Service Letter No. 425

**SUBJECT:** Lycoming Service Bulletin No. 298  
(Fuel and Oil Vent Restriction Requirement for AC Lightweight Diaphragm Fuel Pumps)

DATE: April 20, 1964 Service Bulletin No. 298  
Approved by FAA

SUBJECT: Fuel and Oil Vent Restriction Requirement for AC Lightweight Diaphragm Fuel Pumps

Figure 1. AC Fuel Pump with Vent in Upper Chamber

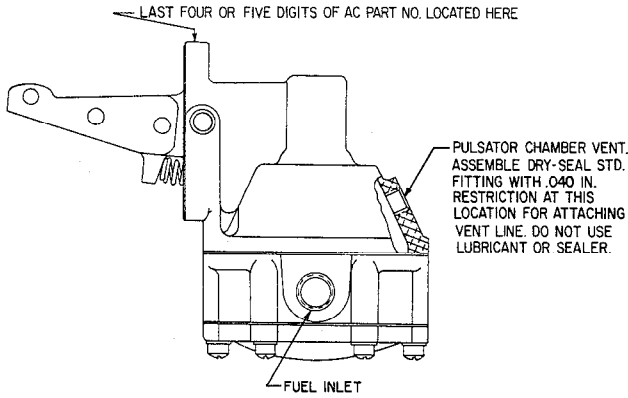
All the fuel pumps affected by this bulletin have a single vent opening in the upper chamber as shown in figure 1, except the P/N 73870 (AC 5656696) which has

1. Determine applicability of this procedure by observing the AC fuel pump part number stamped on the upper edge of the mounting flange as shown in figure 1. Only the last four or five digits of the AC part number are stamped on the pump.

Figure 2. AC Fuel Pump with Two Vent Openings

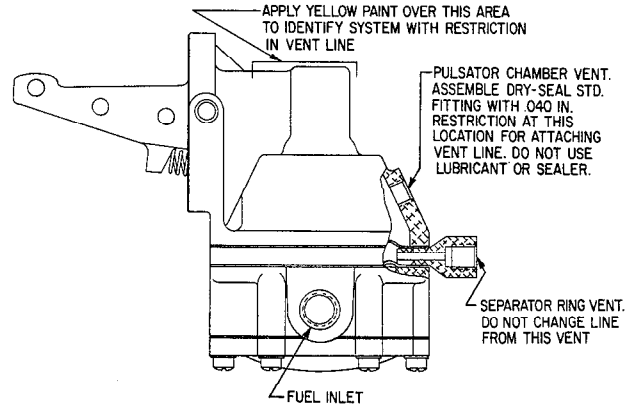
a vent opening in both the upper chamber and the separator ring as shown in figure 2. Regardless of which of the two types are found on the engine, the restriction described herein is to be installed only in the vent opening or line from the upper chamber; do not change the line connected at vent in separator ring.

4. Identify fuel system installation compliance with this service bulletin by yellow paint on top of the fuel pump as indicated in figure 2. If practical, also apply yellow paint at location of restriction in vent line. Enter notation in Engine Log Book to indicate compliance with this service bulletin.

Figure 3 (A). Lycoming P/N 75250 Overboard Drain Adapter

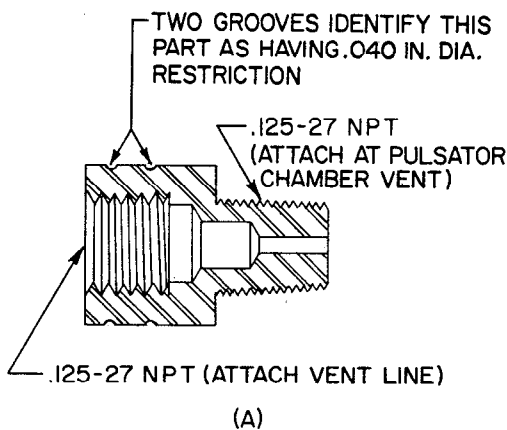
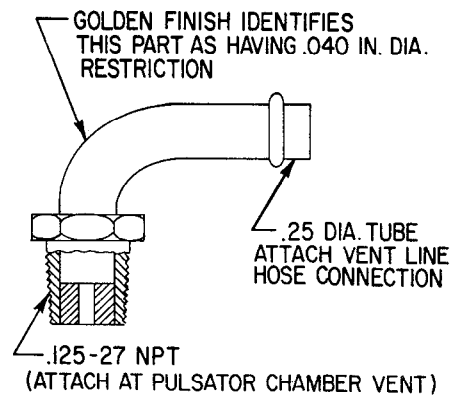
2. There are two restriction adapters available from Lycoming for installation in the tapped vent hole of the fuel pump. Lyc. P/N 75250 adapter which is generally suitable for most aircraft fuel system installations, and Lyc. P/N 75307 elbow adapter which is designed for installations where a hose coupling is required in the vent line, such as the Piper Comanche, Model PA 24-250. Both adapters, and their method of installation, are shown in figure 3.

Both adapters, P/N 75250 and 75307, incorporate a 0.040 inch diameter restriction and are identified as follows: The P/N 75250 adapter has two circular grooves around its hex portion. The P/N 75307 adapter can be identified by its golden color as contrasted with the white, cadmium plated elbow fitting that is usually installed at similar locations.

Figure 4. Typical Connector Fitting with .040 Restriction Installed

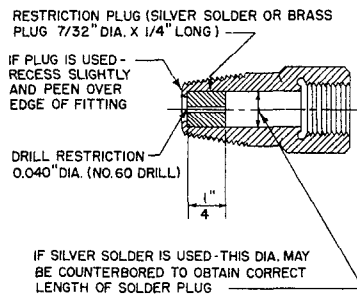
3. In some installations the connector between the fuel pump and vent line may be a standard flared fitting with a 7/32 inch diameter hole in the male end, similar to the one shown in figure 4. There are two methods (a or b) which a restriction may be installed in this fitting, or an alternate third method (c) for putting a restriction in the hose.

a. Fill the hole in the fitting with silver solder (if the fitting is steel) and drill a 0.040 inch diameter hole through the silver solder to form the restriction. If necessary, counterbore the solder filled

area to maintain the length of the restriction to 1/4 inch. Thoroughly clean the fitting and re-install it in the fuel pump.

b. Press a 7/32 inch diameter x 1/4 inch long plug in the hole of the fitting. Peen the end of the fitting to secure the plug and drill a 0.040 inch diameter hole (No. 60 drill) through the plug to form the restriction. 7/32 inch diameter bronze welding rod may be used to make the plug. Thoroughly clean the fitting and re-install it in the fuel pump.

Figure 5. Restriction for Installation in Hose

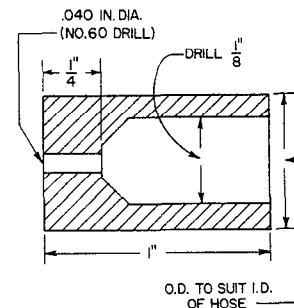
c. Fuel drain lines that employ a hose can be modified by installing the restriction in the hose and securing by a clamp. A restriction can be fabricated, as shown in figure 5, installed in the hose and secured.
